BAMx and CCSF Comments on CAISO 2012-2013 Transmission Study Plan

The Bay Area Municipal Transmission Group (BAMx)¹ and the City and County of San Francisco (CCSF) appreciate the opportunity to comment on the CAISO Draft 2012-2013 Transmission Study Plan (Study Plan). The comments and questions below address the presentations made by the CAISO during the February 28, 2012 Stakeholder meeting.

Figure 1: A Comparison of the 2020 Load Projection/ Energy Consumption (GWh) in PG&E and SCE Planning Areas under CEC's Preliminary and Revised Demand Forecasts in 2020

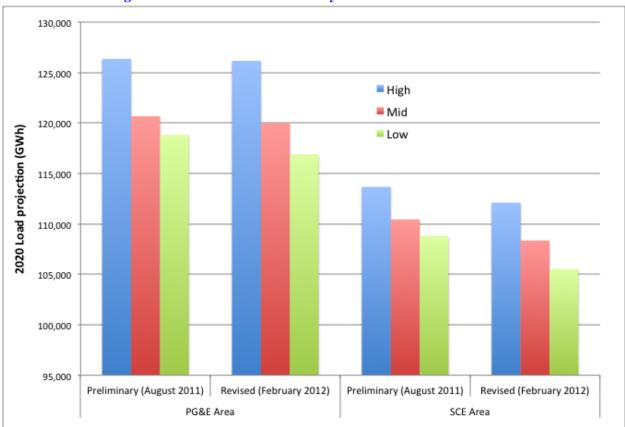
Figure 1 below shows that both for the PG&E and to a greater extent for the SCE planning areas, the 2020 load projections (GWh) are lower in the CEC's revised forecast than in the preliminary forecast. This reduction in the revised load projections is primarily attributed to greater self-generation (including the effects of Self-Generation Incentive Program-SGIP, CSI, and other

programs) as well as higher Conservation/Efficiency Impacts amounts in the revised forecast than in the preliminary one.

BAMx and CCSF strongly urge the CAISO to consider utilizing the latest CEC demand forecast for the annual, five-year and ten-year Base Cases during the period of 2013-2022.
